AGENDA
CASCADE CHARTER TOWNSHIP PLANNING COMMISSION
MONDAY, November 18, 2024
7:00 PM
2870 JACKSMITH AVE SE

Public may access the meeting via video conference software Zoom

**RE: Plan Review Response MSI Surfaces Renovation
Case 24-3873 – 5085 Kraft Ave SE
Project Number: 2400360**

C2

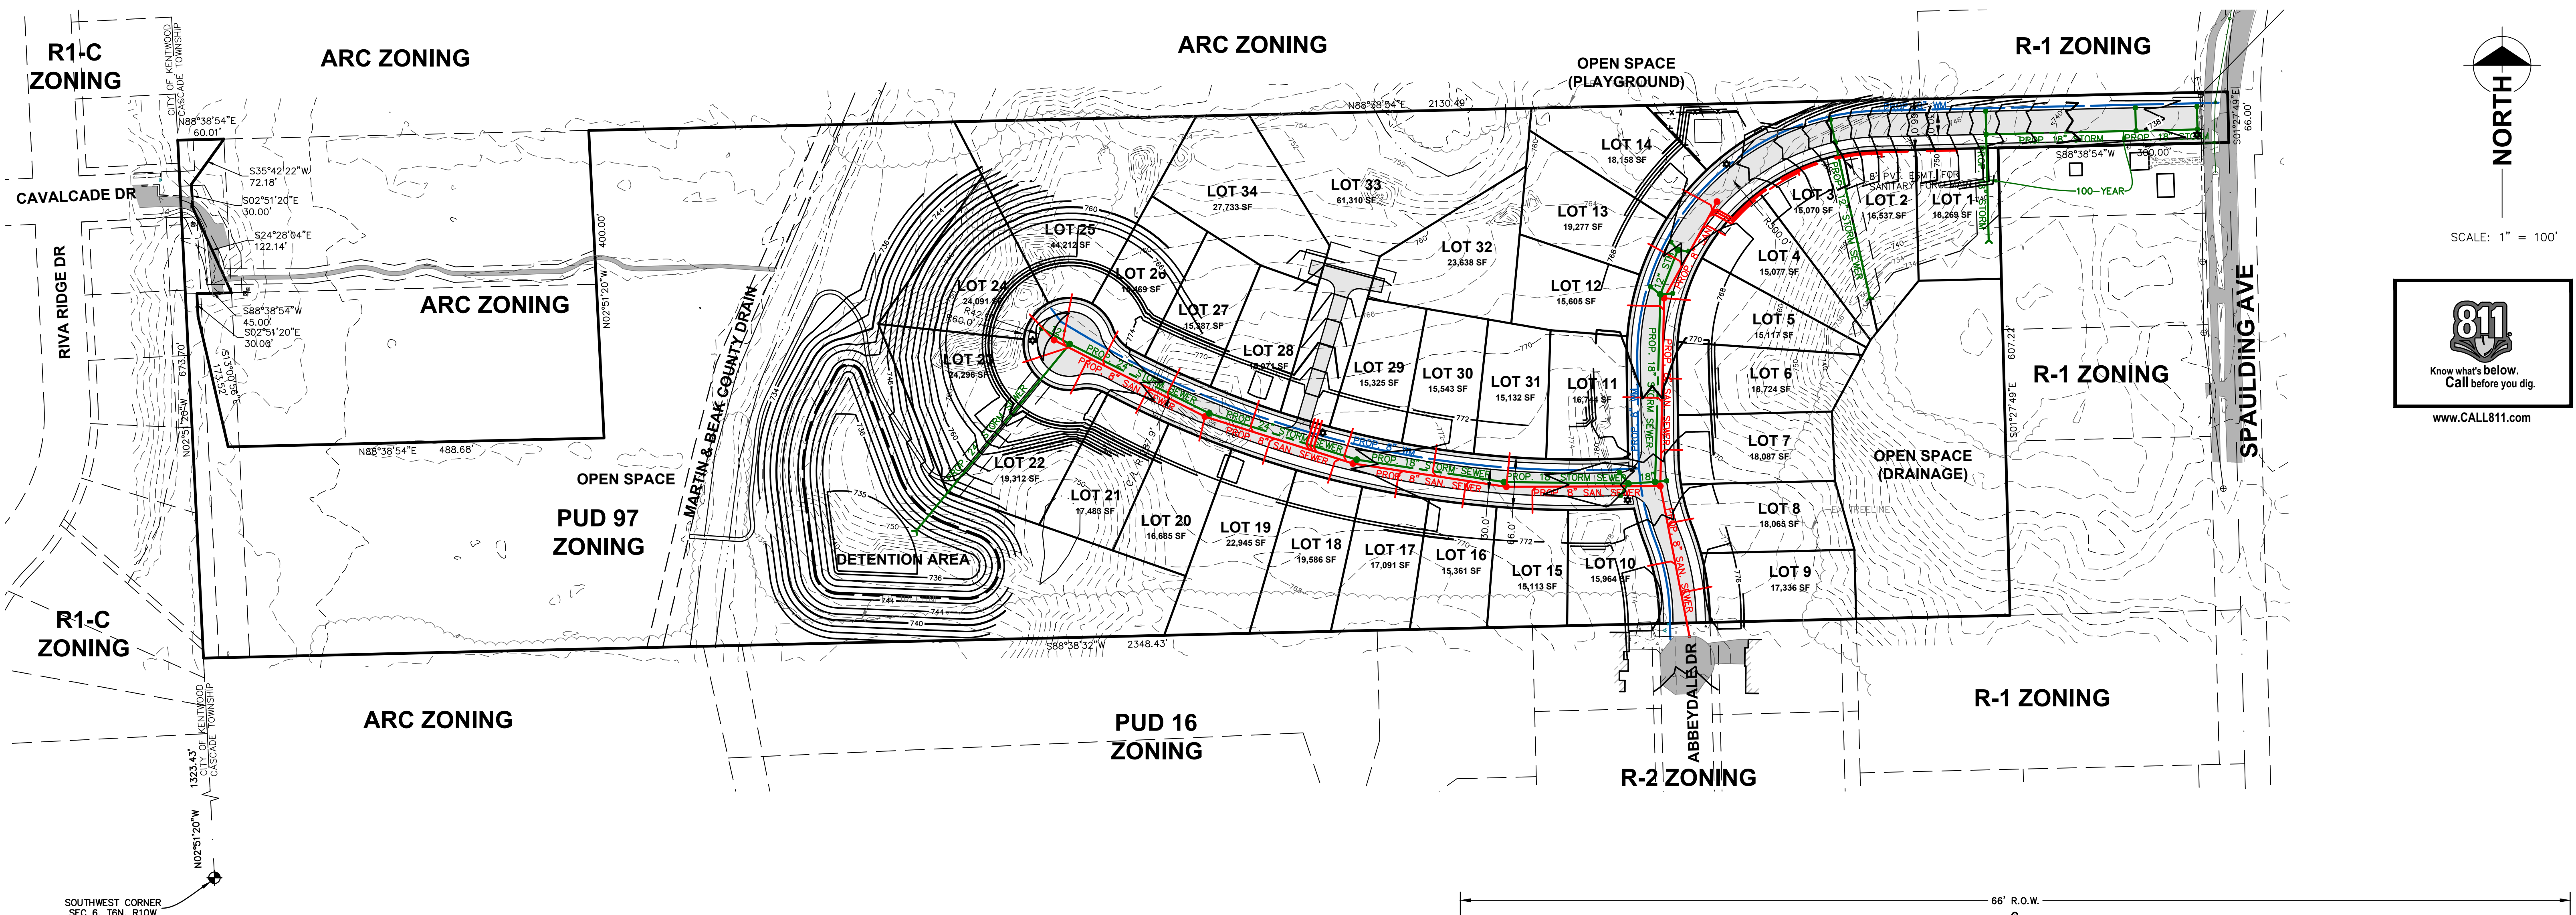
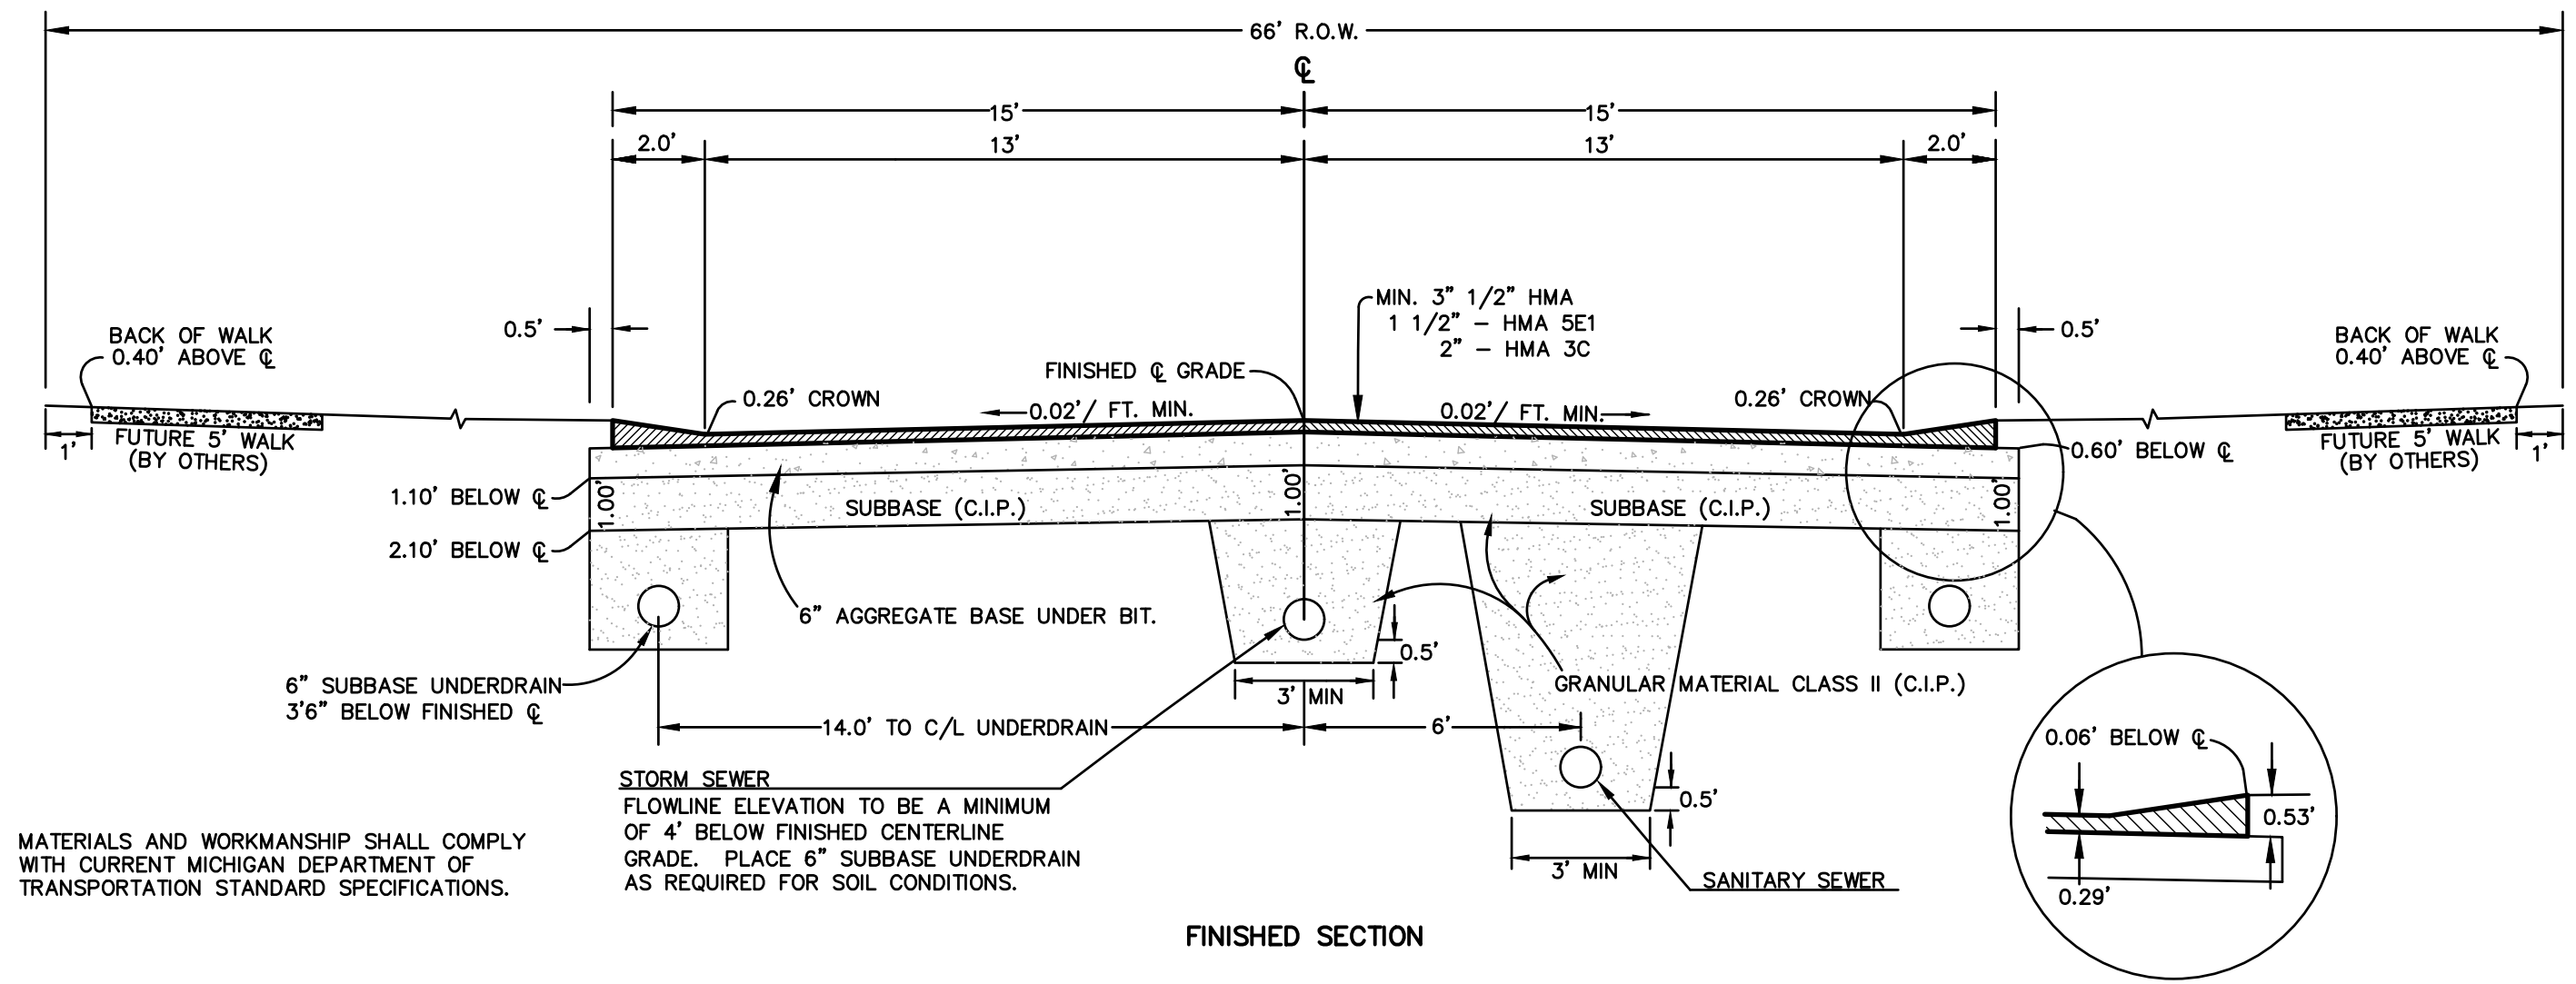
“I am fine with the submission if we are taking it to be preliminary. The applicant will have to follow up with detention basin and storm details later, then. The general layout and calculations otherwise appear like a reasonable start.

There is a fair bit of scrutiny that could be had over some parcels. Lot 21 is 1/3 hill and 1/3 wetland. The storm water easement between 22 and 23 will be interesting once we

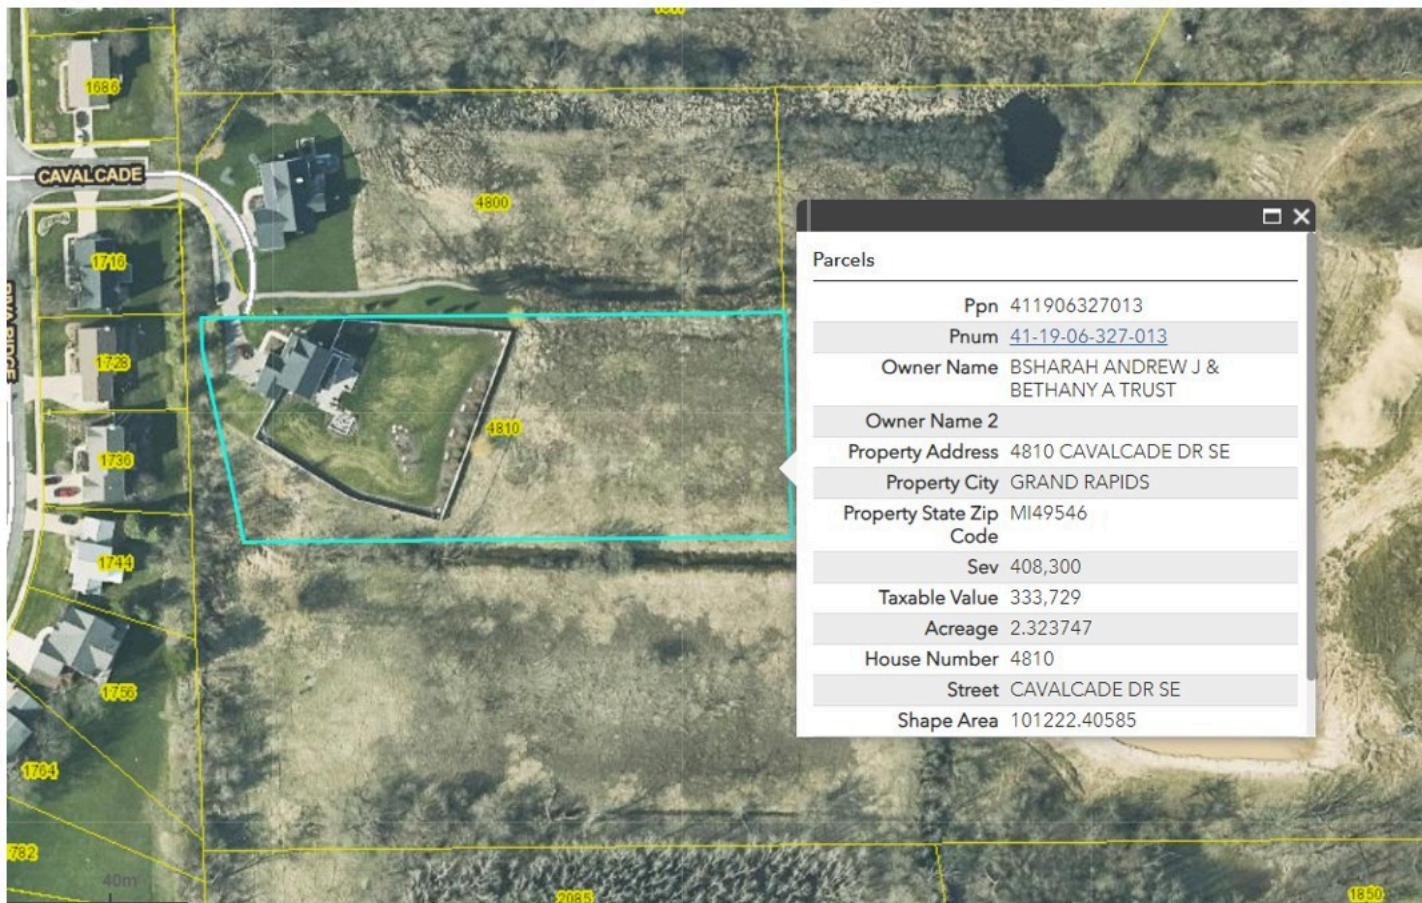
After looking at the proposed development, I was wondering what the plan was for the existing path and easement between our yards? Also, I was hoping to know more about the intention of the proposed bike path that goes along the Martin Beak drain way?
